**Re: Sunset Lake RV Park (00933) Secondary Treatment
Final Approval – PR# 199-2011**

CHECKLIST FOR WATER SYSTEM PLAN REVIEW

Name of System: Sunset Lake RV Park
Name of Project: Secondary Treatment
Plan Review#: 199-2011
Design's Engineer: Chuck Chamberlain

Uni-Dose[®]

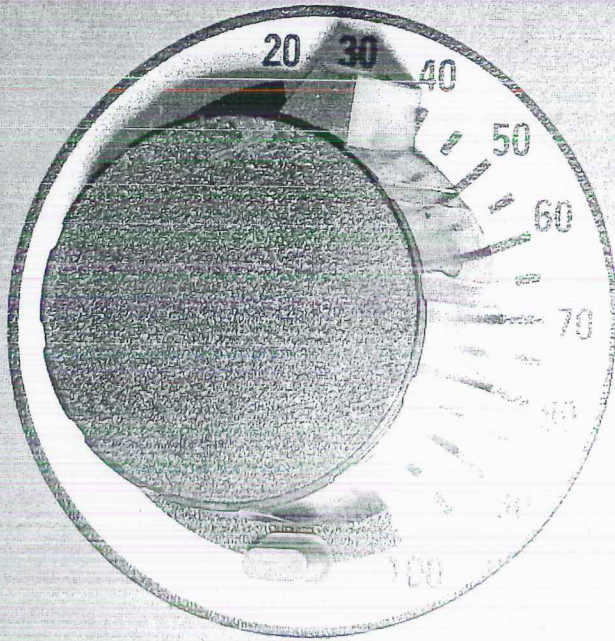
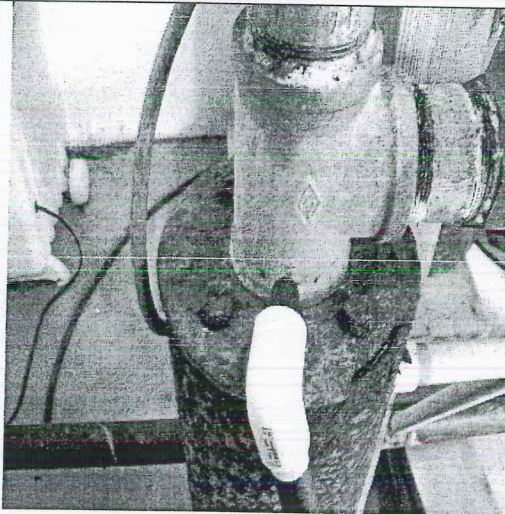
Having received documentation from Maureen Taylor on November 15, 2013 that the chlorination pump was replaced with an NSF approved Milton Roy Uni-Dose pump (Model #U031-281TT) in accordance with my letter dated May 21, 2013, the **treatment system is granted Final Approval**. The treatment system consists of:
